The Captain stated that they had struck some submerged object and we found 1 keel plate and the aboard plate on both sides & up about 8 ft. abaft the collision bulkhead. This damage now being dealt with.

Re - Marengo

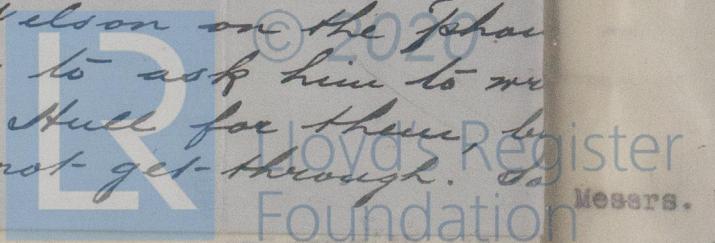
that they derive no assistance  
by curvature of section. The  
rivets in a number of tank  
side lugs are also slack, gussets being  
fitted 3 spaces apart & run up the  
tank knee thus . In our  
opinion these gussets should always  
be fitted to give a direct pull, as  
when bent in this case<sup>\*</sup> additional  
stresses come on the top rivets of  
tankside lug before the effect of  
the gusset comes into action. Mr.  
Wilson himself will give our general  
opinion on the whole question  
on completion of the present  
survey, but it is essential that  
we should have the approved plans  
in order to guide us & to see that  
the whole of the Committee's require-  
ments have been carried out in  
the building of the vessel.
